## **Access Compliance Report Public Rights-of-Way** (Curb Ramps)

Intersection ID: 45499 Main Street: BUGGY HORSE RD Cross Street: GRASSY CROPS RD Location: ADA ID: B421FC95740F Ramp Type: PerpDiag Initial Pass/Fail: Fail **Overall Compliance: No Severity Score:** 42.5

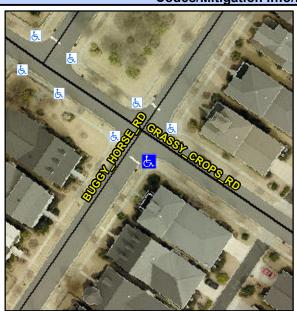
Possible Solutions: **Remove & Replace Curb Ramp With** Two New Directional Ramps or Equivalent. Surveyor Notes: N/A PROW/ADA: Not Found, R304.5.1, R304.2.2

Field Measurements/Component Compliance							
	Compl	iance Description	Data	Compliance		Description	Data
	N/A	Ramp Length (in)	72.0	No	Ram	Slope (%)	13.0
	No	Ramp Width (in)	32.0	Yes	Ramp	XSlope (%)	1.4
	N/A	Flare Type LT	N/A	N/A	Flare	Type RT	N/A
	N/A	Flare Slope LT (%)	N/A	N/A	Flare	Slope RT (%)	N/A
	N/A	Flare Traversable LT?	N/A	N/A	Flare	Traversable RT?	N/A
	N/A	Landing Length (in)	N/A	N/A	DWS	Provided?	N/A
	N/A	Landing Width (in)	N/A	N/A	DWS	Contrast?	N/A
	N/A	Landing Slope (%)	N/A	N/A	DWS	Length (in)	N/A
	N/A	Landing X Slope (%)	N/A	N/A	DWS	Full Width?	N/A
	N/A	Landing Curb? (Y/N)	N/A	N/A	DWS	Offset (in)	N/A
	N/A	Shared Landing?	N/A				
	N/A	Gutter Ponding?	N/A	N/A	Gutte	er Slope (%)	N/A
	N/A	Gutter Lip Ht (in)	N/A	N/A	Gutte	er X Slope (%)	N/A
	N/A	Painted X Walk1?	No	N/A	Paint	ed X Walk2?	No
		X Walk 1 Direction	To NE		X Wa	lk 2 Direction	To NW
	N/A	X Walk 1 Width (in)	N/A	N/A	X Wa	lk 2 Width (in)	N/A
